2.5 Geology, Seismology, and Geotechnical Engineering

In Section 2.5, "Geology, Seismology, and Geotechnical Engineering," of the SSAR, SERI provided a detailed description of the geological, seismological, and geotechnical engineering properties of the ESP site. In this SER, Section 2.5.1, "Basic Data," describes basic geological and seismological data, especially the data published since 1986 for the area within a 200-mile radius of the ESP site, and presents updated seismic sources. Section 2.5.2, "Vibratory Ground Motion," evaluates the vibratory ground motion for the ESP site and analyzes the safe-shutdown earthquake (SSE) ground motion. Section 2.5.3, "Surface Faulting," describes the potential for surface faulting at or near the surface of the ESP site. Section 2.5.4, "Stability of Subsurface Materials and Foundations," presents the results of site geotechnical investigations and discusses the stability of subsurface materials and foundations. Section 2.5.5, "Stability of Slopes," defers the analyses for slope stability at the site and dam performance, respectively, to the COL stage. Finally, Section 2.5.6, "Embankments and Dams," briefly states that no embankments exist wi

Figure 2.5.2-1 (SSAR 2.5-57) Deaggregation for low-frequency (Sa 1–2.5 Hz) ground motions at the GGNS ESP site

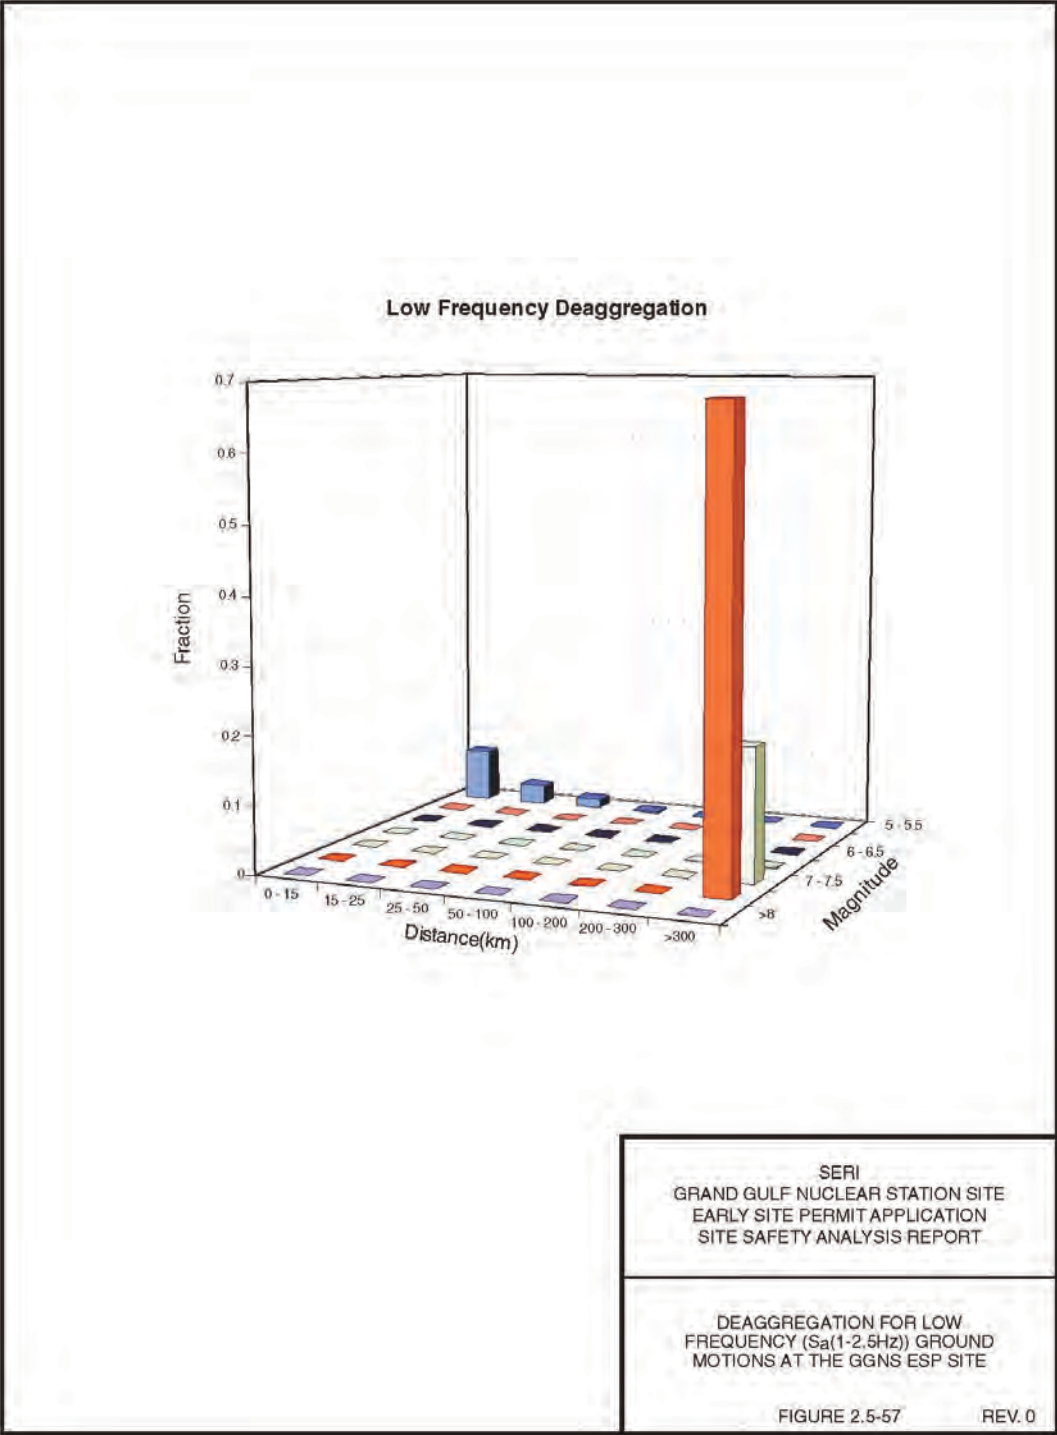
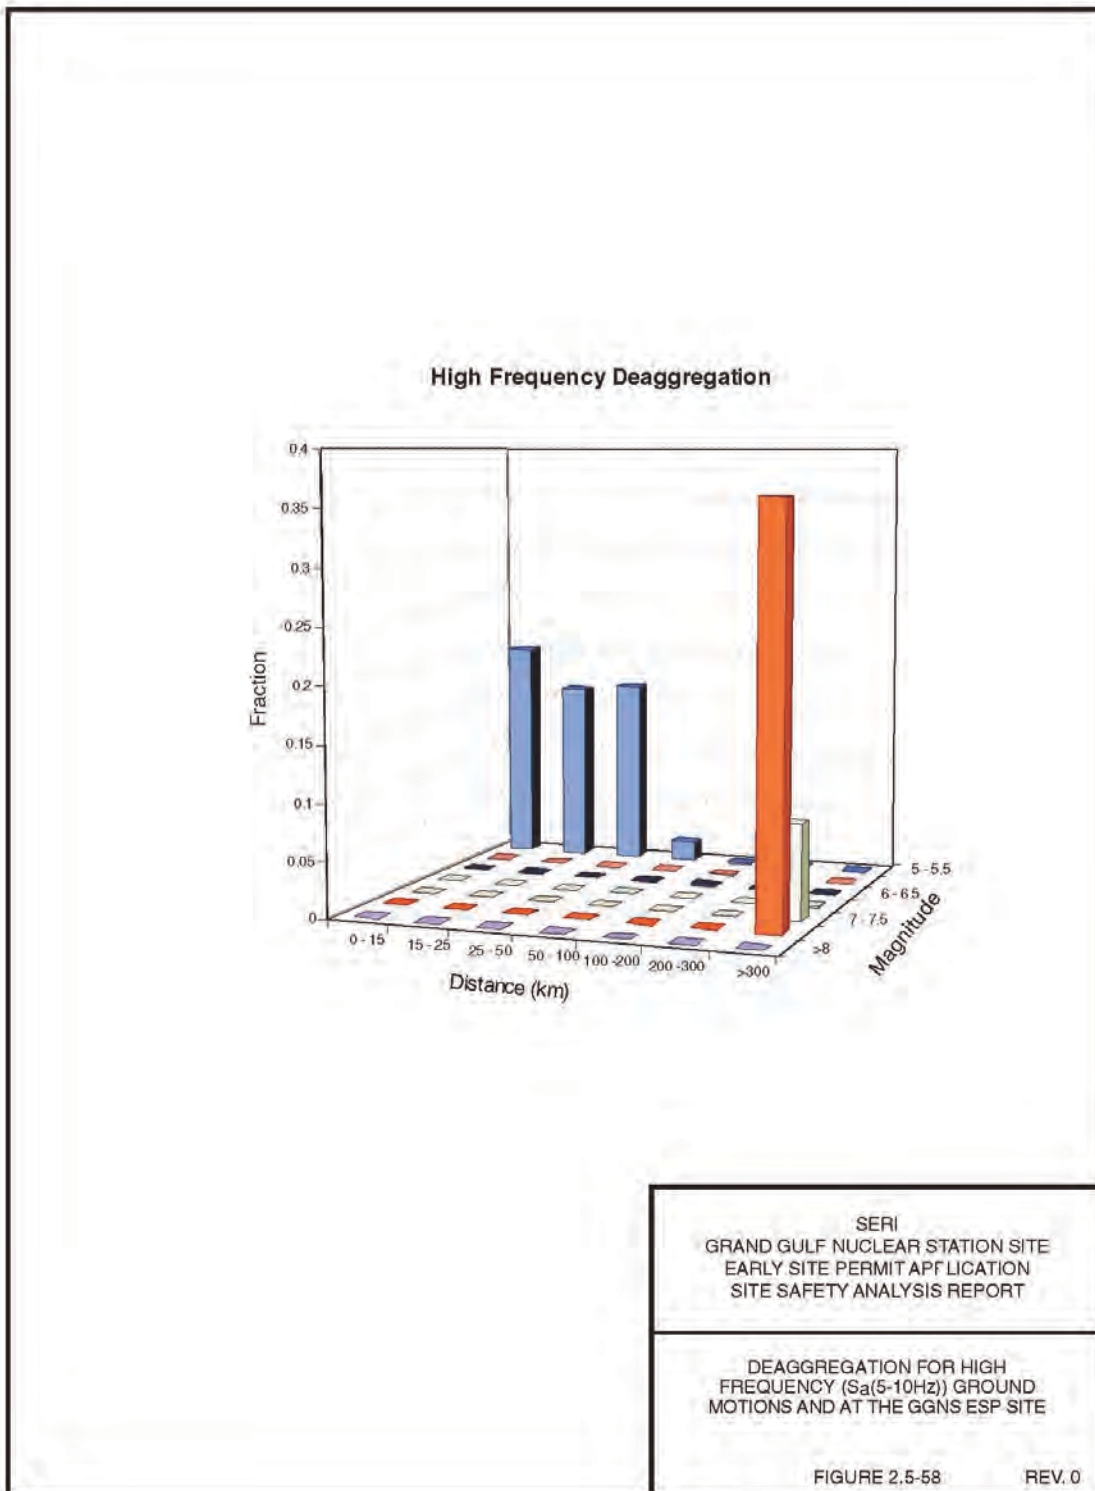
In RAI 2.5.2-9, the staff asked the applicant to explain why the SRSZ, with a magnitude as large as 6.0–7.0 and a distance at 81–206 miles, makes no contribution to the deaggregation results. In its response, the applicant stated the following:

In RAI 2.5.2-10, the staff asked the applicant explain why the magnitude-distance bin, including the controlling earthquake, does not contribute to the high-frequency deaggregation. In its response, the applicant stated that the controlling earthquake for a given frequency range is the mean magnitude and mean distance of the deaggregation distribution. If deaggregation is multimodal or bimodal as in the Grand Gulf case, the resulting mean may not correspond to the magnitude values that are actually defined in the distribution.

The purpose of the magnitude-distance deaggregation is to provide a measure of the relative contribution of events (of different magnitude-distance pairs) to the total hazard. The deaggregation graphs in the SSAR show the relative contribution of earthquakes to the 10^{-5} median. The fact that events associated with the Saline River source (and all sources in this distance range) do not contribute to the 10^{-5} median hazard for the Grand Gulf site is primarily due to the fact that the overall rate of earthquake occurrences ($M_w > 5$) at these distances is extremely low. Further, the rate of occurrence of earthquakes of magnitude 6.0–7.0 is thus much lower. The result is that the estimated ground motion hazard at the Grand Gulf site is extremely low and, in a relative sense, makes little or no contribution to the 10^{-5} median hazard.

In RAI 2.5.2-9, the staff asked the applicant to explain why the magnitude and distance bins corresponding to the SRSZ make no contribution to the deaggregation result, although the SRSZ maximum earthquake magnitude is as large as 6.0–7.0 and at a distance of 81–206 miles from the ESP site. The applicant stated that the overall rate of earthquake occurrence (M_w greater than 5) at these distances for the SRSZ was too low to contribute to the 10^{-5} median hazard. However, the staff notes that in SSAR Section 2.5.2.1.3 and in its response to RAI 2.5.1-3, the applicant stated that the activity of the SRSZ has a probability of 0.5 for its existence. This probability of existence implies that the SRSZ has a 50 percent chance to produce an earthquake with a magnitude between 6.0–7.0. The applicant also assigned three different return periods (388, 1725, and 3505 years) to the characteristic SRSZ earthquake model based on paleoliquefaction data. As such, a SRSZ earthquake with a 3,505-year return period should repeat about 30 times during the 100,000-year time span that is associated with a 10^{-5} probability of exceedance. Therefore, the staff was not certain why the magnitude and distance bins corresponding to the SRSZ do not contribute to the hazard at the 10^{-5} probability level.

After reviewing the applicant's response, the staff concluded that it does not adequately address the absence of the SRSZ's contribution to the deaggregated seismic hazard at the ESP site. The absence of the hazard contribution from the SRSZ is probably due to the applicant's computational procedure for this particular seismic zone, which has a 0.5 probability of activity. To confirm this conclusion, the staff performed an independent evaluation using seismic sources similar to those used by the EPRI-SOG for the ESP site. For its evaluation, the staff also used a source weighting scheme similar to that used by EPRI -SOG and added a new source similar to the SRSZ. The staff then calculated and deaggregated its seismic hazard using two methods. The first method, which is the method adopted by the applicant model, resulted in no contribution from the SRSZ to the deaggregated seismic hazard result. The second method resulted in the appearance of a contribution from the SRSZ to the site hazard. The second method differs from the first one in that, instead of using those magnitude and distance bins associated with a 0.5 probability of non-activity in the deaggregation, they were omitted from the calculation. Implementing the second approach, the combined contribution from all relevant magnitude (M 6-6.5, M 6.5-7 and M >7.0) and associated distance bins are about 10 percent relative seismic hazard contribution for 5 and 10 Hz and 5 percent for 1 and 2.5 Hz, respectively. The staff's evaluation suggests that the SRSZ missing hazard contribution is from the applicant's computational procedure because more than half of the hazard values in the corresponding magnitude and distance bins for the corresponding non-activity logical tree branches are zeros. The staff asked the applicant to reevaluate the seismic hazard contribution from the SRSZ based on the staff's findings since the result could potentially affect the determination of the controlling earthquakes, and thus the determination of the SSE.

In response to the staff's evaluation, the applicant performed a sensitivity test to evaluate the impact of the missing SRSZ contribution to the controlling earthquakes. When increasing the hazard contribution from the SRSZ, the applicant balanced the total hazard by decreasing the hazard contribution from other sources, including the NMSZ, which ensured the NRC staff that the absence of the SRSZ contribution only caused by the applicant's deaggregation process. The applicant stated that the results from the sensitivity test indicate there is a very small change to the 5 and 10 Hz controlling earthquakes (see Table 2.5.2 -1) and associated median rock response spectrum. The calculated differences in response spectrum values ranges from +0.06 to -0.23 percent of the comparable Grand Gulf response spectra. The applicant concluded that even if the staff's approach were used to deaggregate the controlling earthquake, which shows that the SRSZ may contribute up to 5 to 10 percent of the median hazard, the contribution would not result in a significant change to the median rock ground motion at the Grand Gulf site. Based on the results of the applicant's sensitivity test and also the fact that the SRSZ is relatively far from the ESP site (130 to 329 km), the staff concurs with the applicant on its conclusion with regard to the specific situation of the ESP site. Therefore, this open item is resolved.

Figure 2.5.4-5 (Updated final version of SSAR Figure 2.5-87)
 Shear Modulus Reduction Curves For Loess

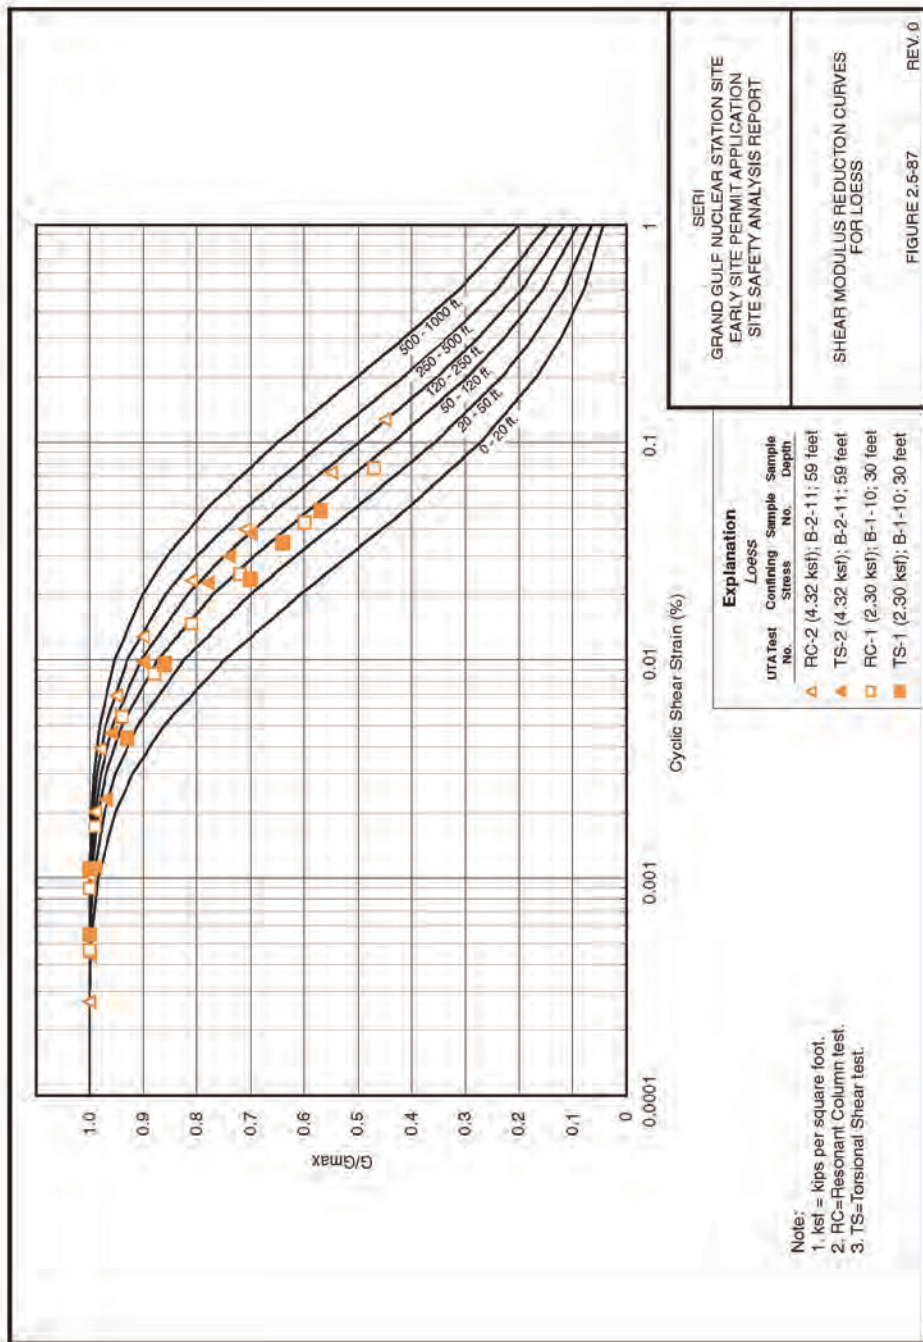
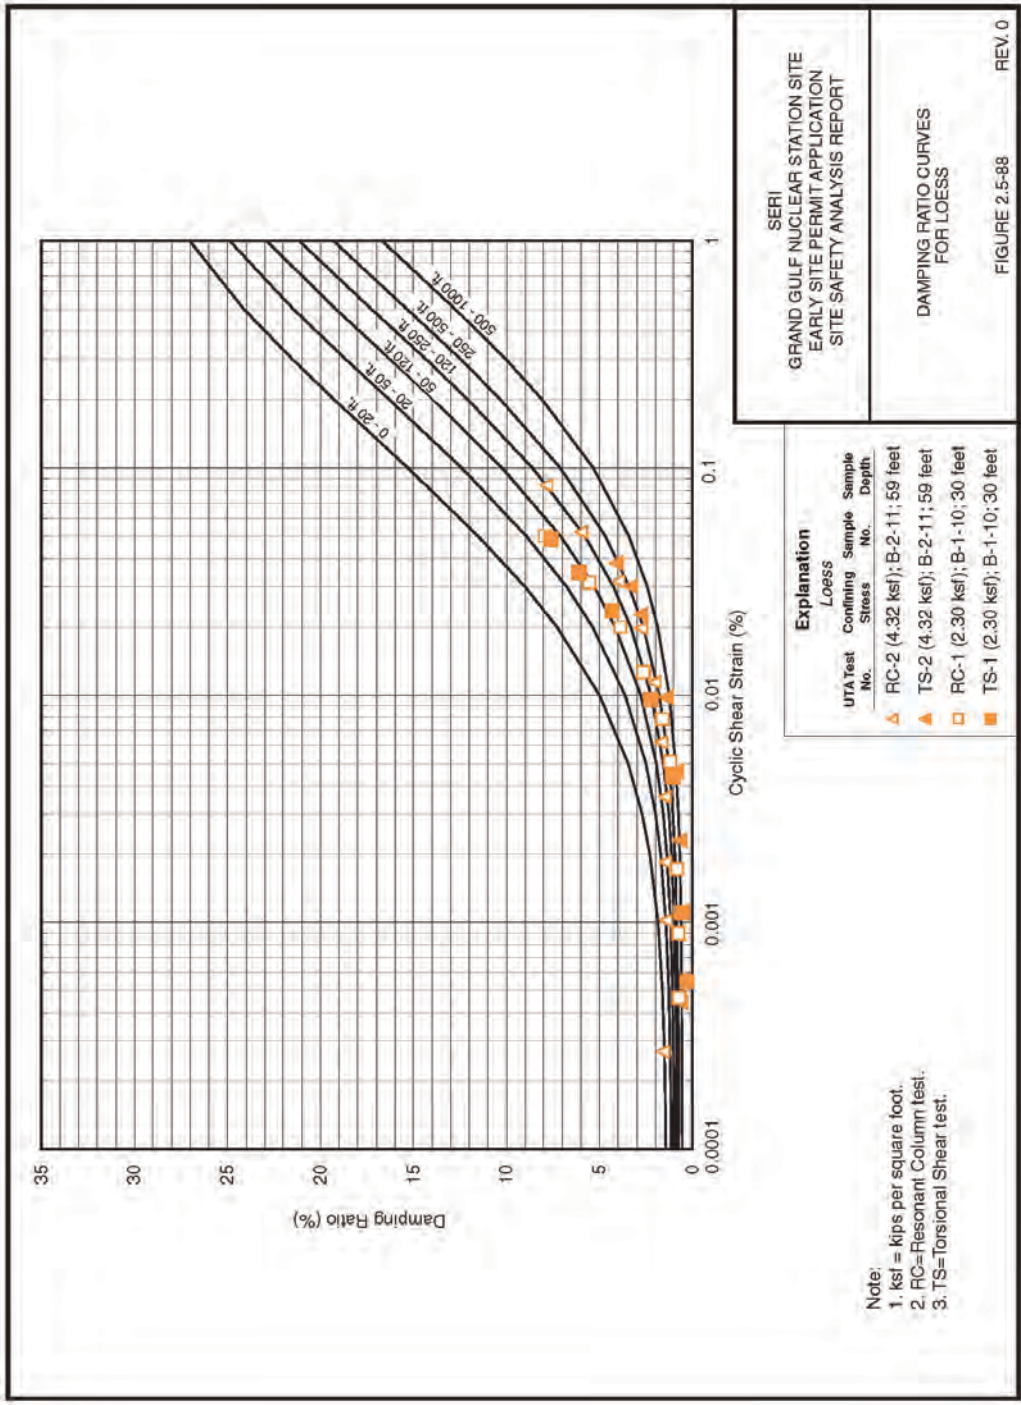
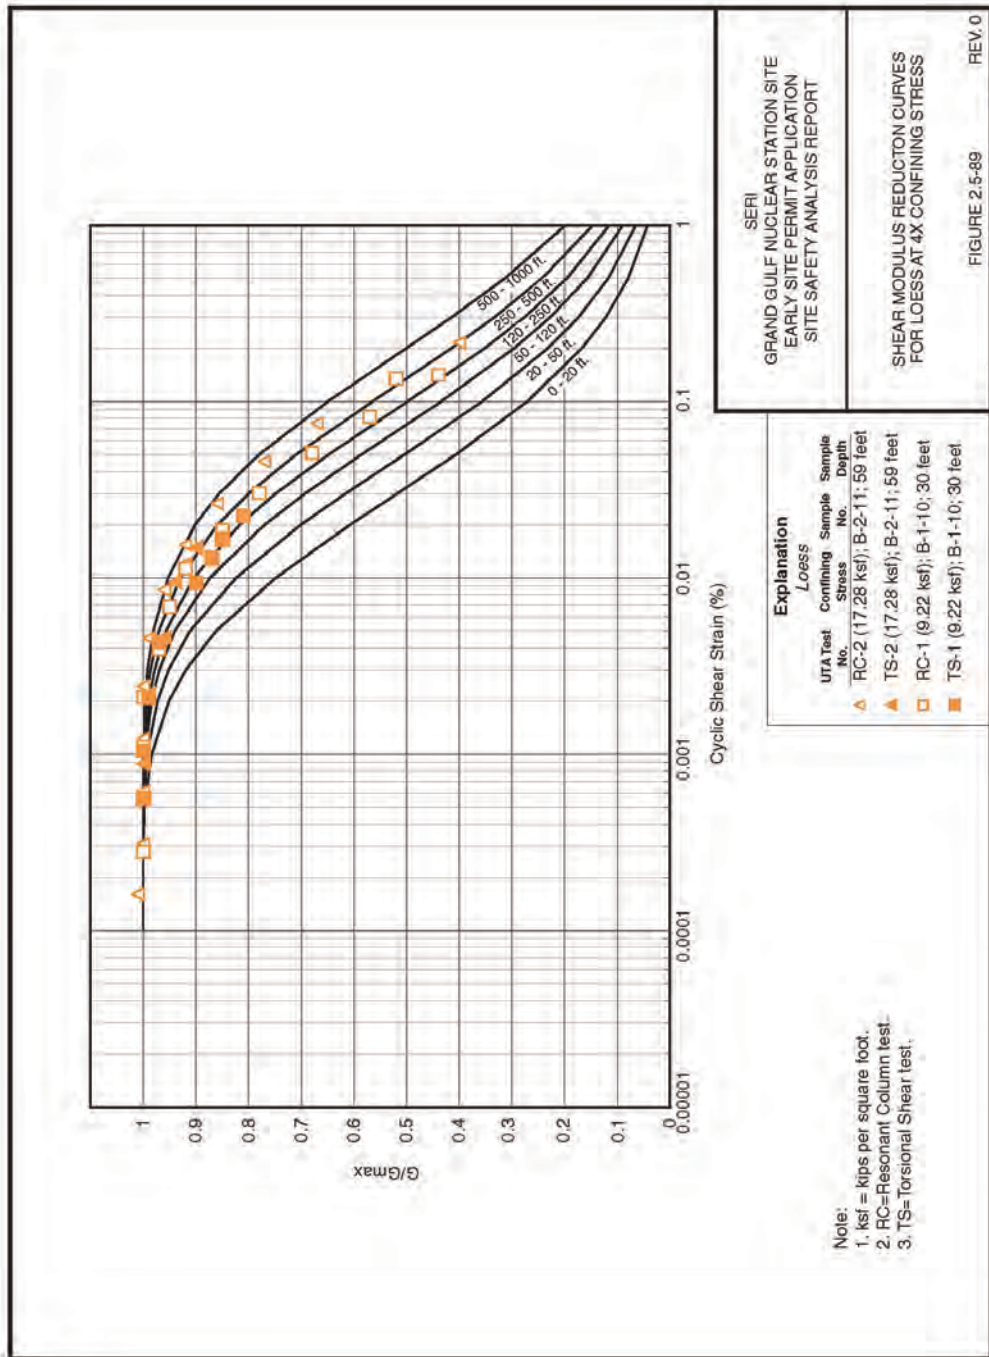
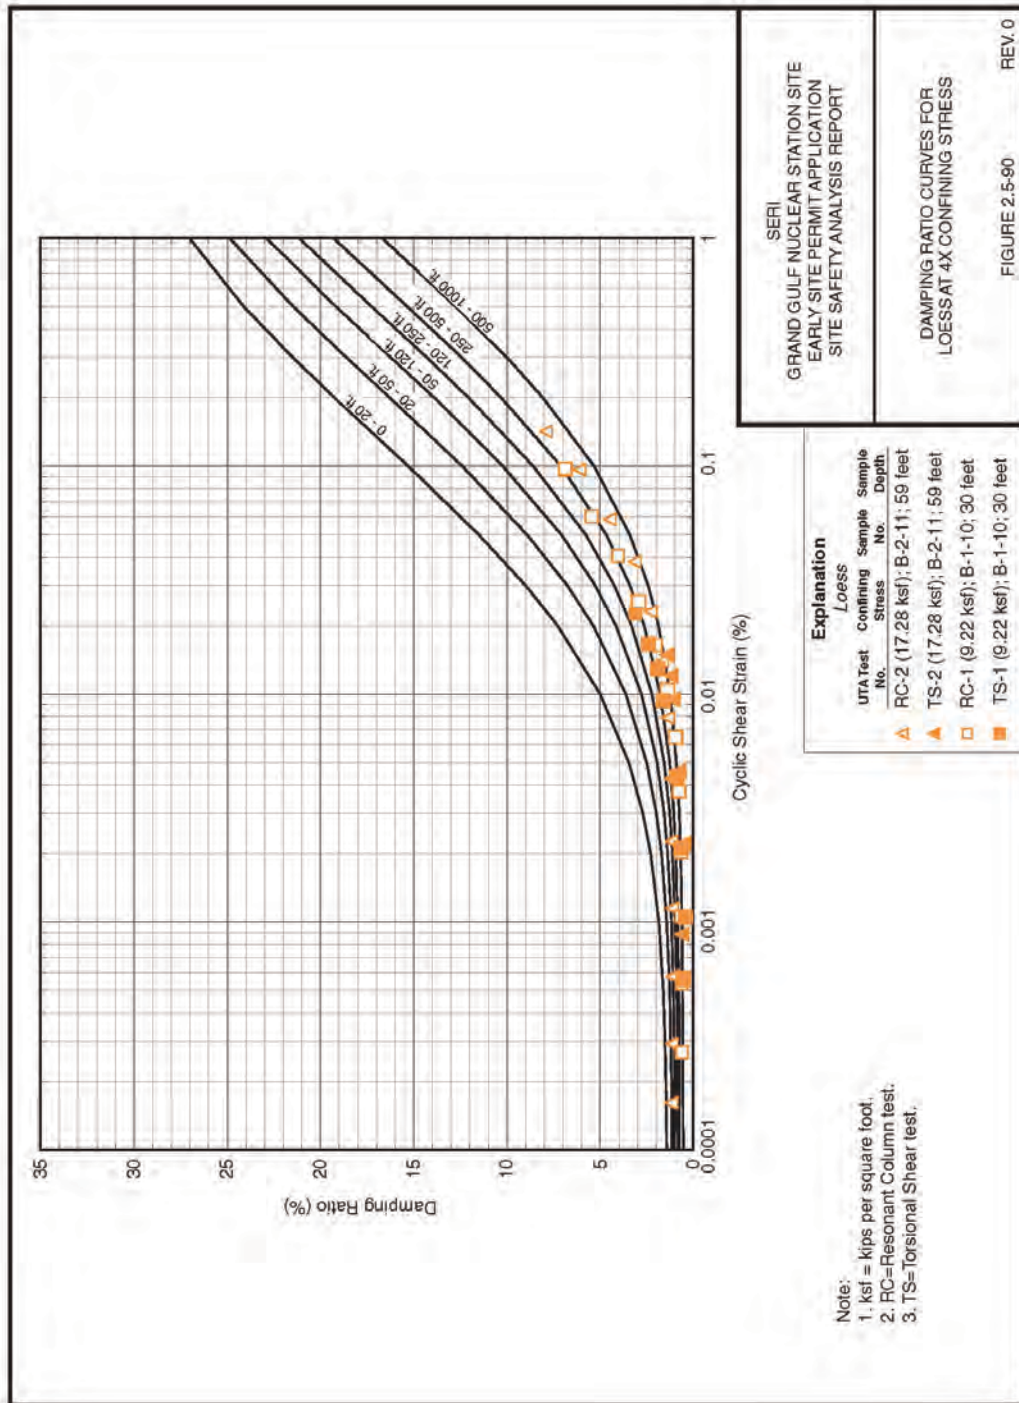
In RAI 2.5.4-7, the staff asked the applicant to provide its rationale for not incorporating these effects in the site response calculations and to evaluate the potential impact of these modifications on the computed surface UHRS. In its response, the applicant referred to its response to RAI 2.5.4-6 and stated that the analysis and selection of the appropriate EPRI-TR curves for shear modulus reduction and hysteretic damping fully account for the effects of possible disturbance to the test specimens resulting from stress release during sampling, as well as possible movements during testing. The applicant considered the effects of sample relaxation by examining the results from testing soils at both the estimated in situ confining stress and 4 times the estimated in situ confining stress. The applicant plotted these two data sets together on the EPRI-TR base curves as shown in Figures 2.5.4-5 through 2.5.4-12, which replicate SSAR Figures 2.5.4-87 to 2.5.4-94. The two data sets were weighted to select the most representative EPRI-TR curve.
